ANN ARBOR HISTORIC DISTRICT COMMISSION**Staff Report**

ADDRESS: 338 Mulholland Street, Application Number HDC16-159

REPORT DATE: September 8, 2016

APPLICATION: The applicant seeks HDC approval to reconstruct the front porch foundation, replace an existing two-track paved driveway with a full concrete driveway, and remove a concrete walkway along the house.

BASE MAP

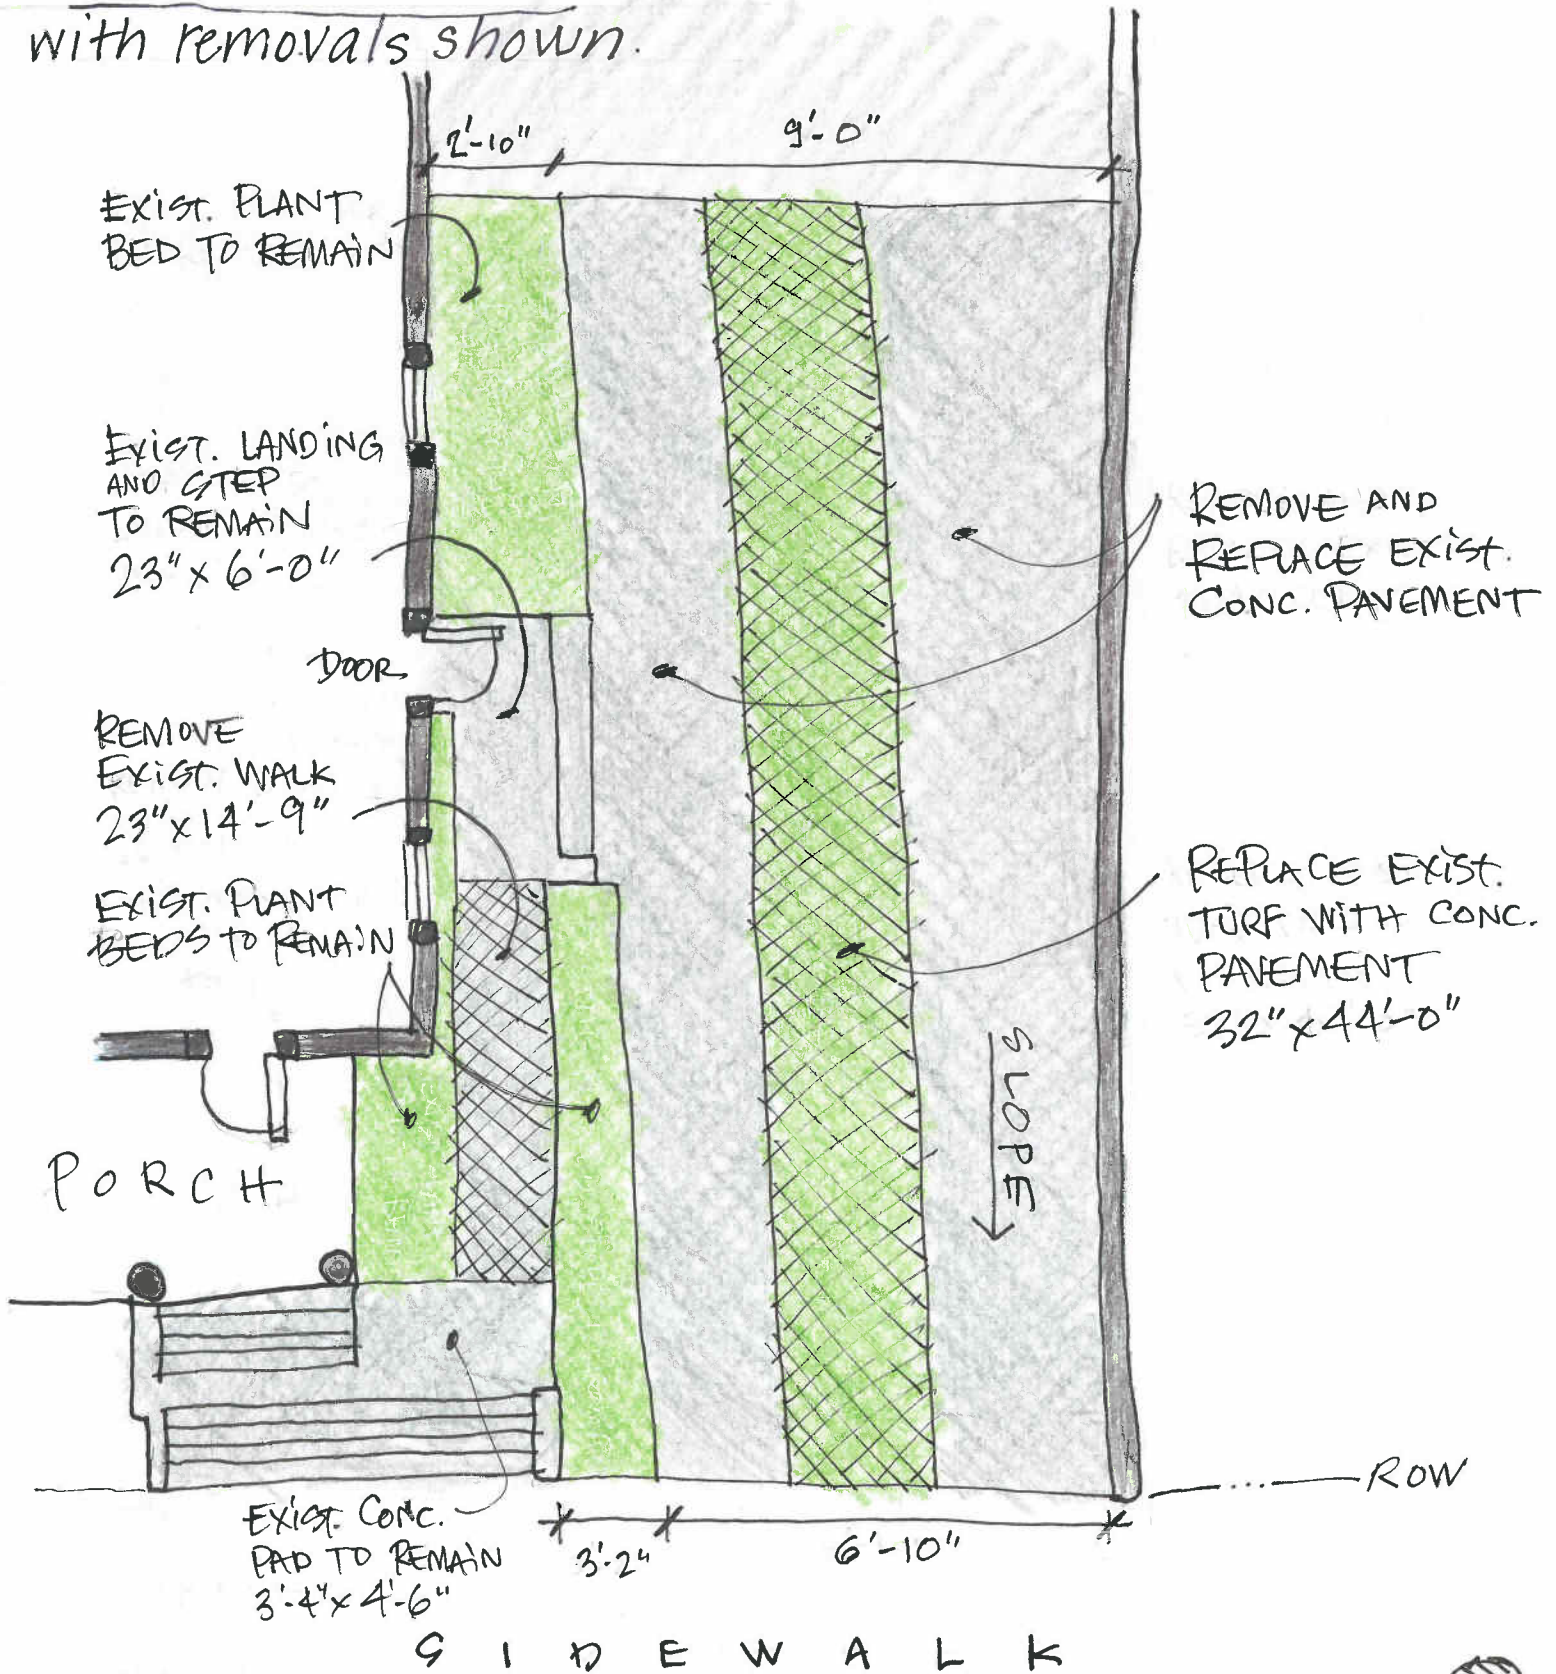
1. The existing concrete two track driveway covers the first 44' of the driveway. Beyond that is full width concrete leading into the garage. The tracks are narrow and not configured correctly for modern vehicles. The rock retaining wall on the south and large curb on the north, and the narrow width of the drive, make exiting a vehicle parked on the lower 44 feet of drive challenging. The owners also have difficulty growing anything on the strip between tracks since it is so often driven over. By pouring a full concrete driveway, they will be able to improve the overall maintenance, drainage, and usability of the drive.

2. By removing the sidewalk that runs between the structure and driveway, the owners will be able to moderate the grade challenges to some degree. Concrete landing pads will be left at the top of the front walk stairs and at the home's side door.

PROPOSED

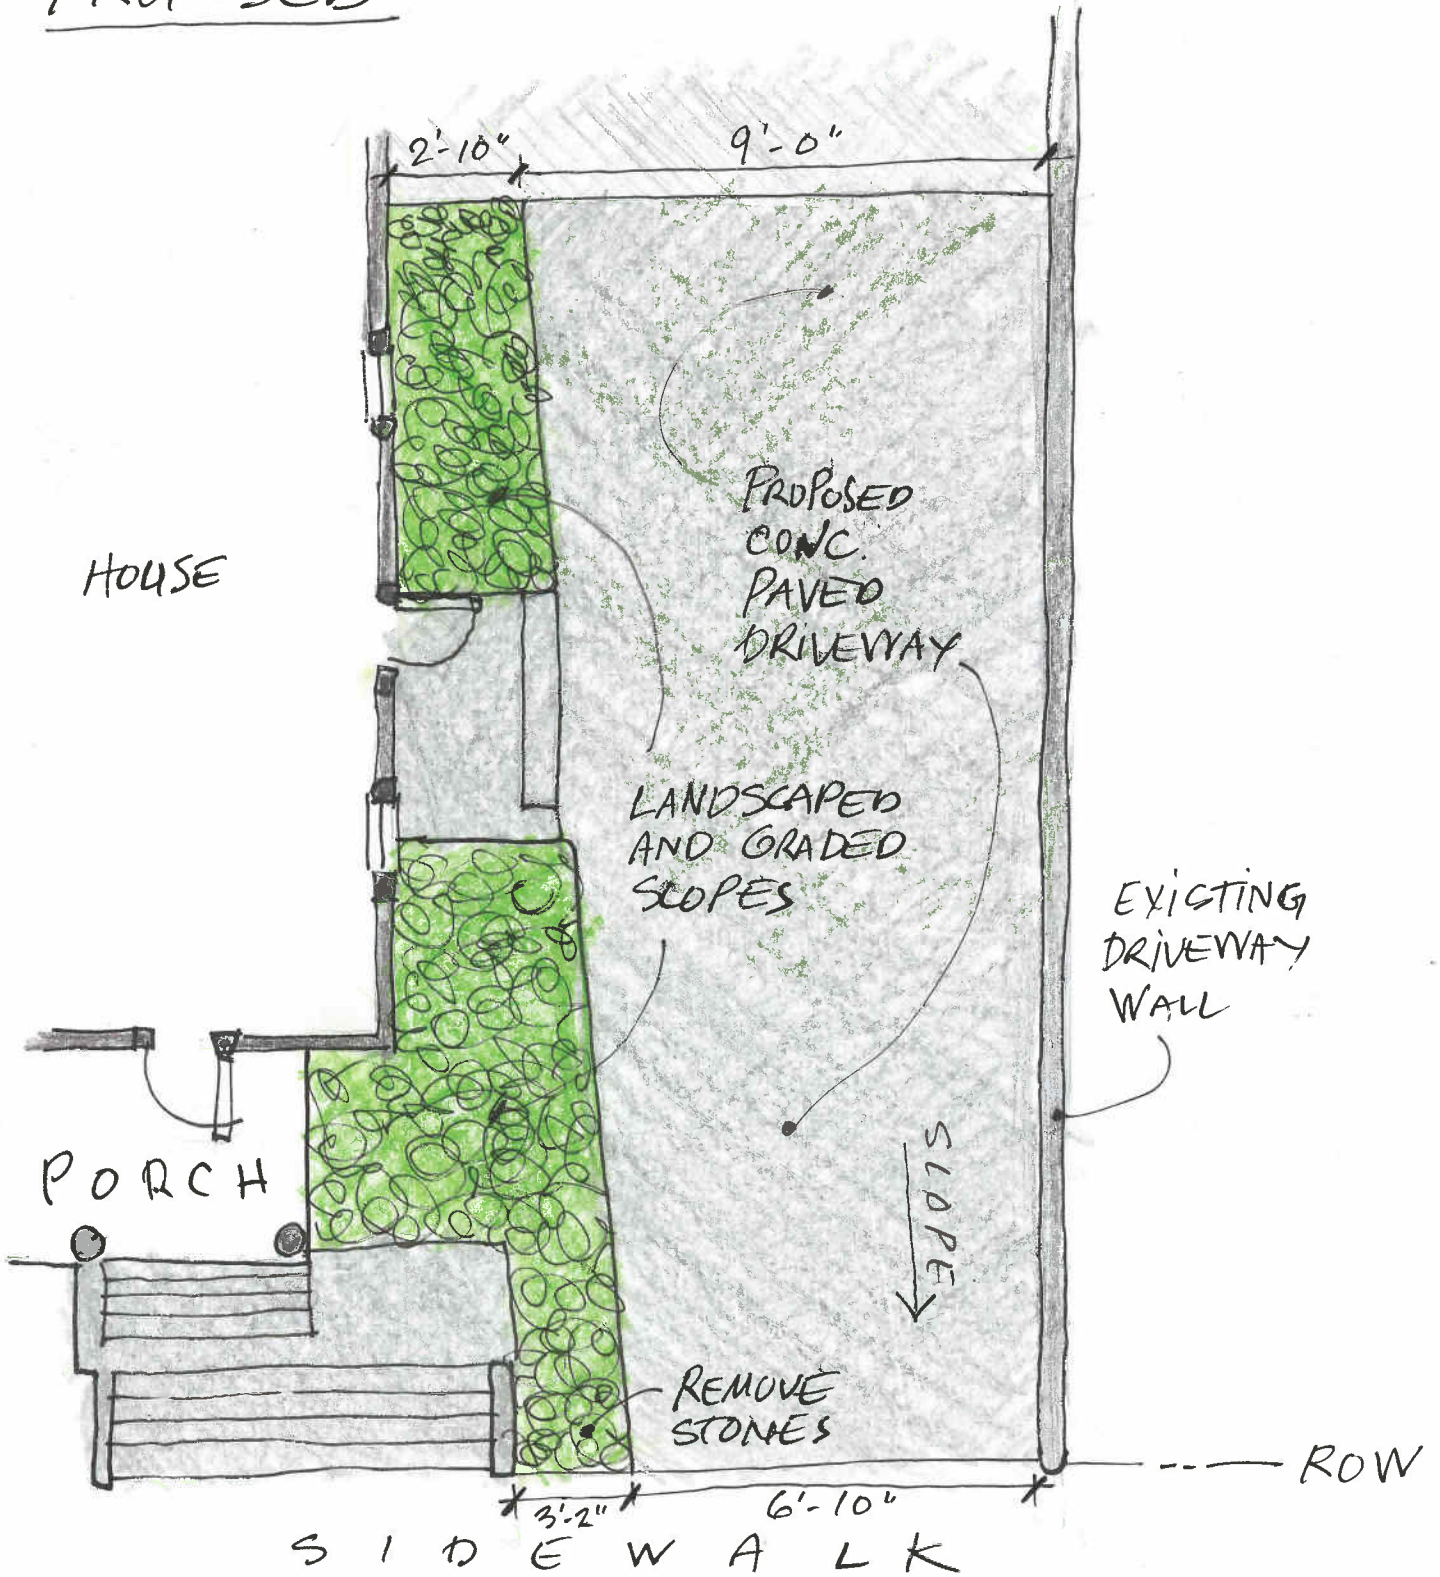
replace
foundation
walls on porch

remove sidewalk

Driveway tracks incompatible with car tracking

Porch foundation reconstruction to use “Hewn Concrete Block” from Fendt which closely matches the existing, original block. New foundation wall will match raised joint pattern and grout. See photo, below, of a sample block in front of porch foundation.

3. The porch foundation will be reconstructed with a block material from Fendt that closely replicates the current sculpted block, and will have grout and a raised joint pattern that match the original as closely as possible.
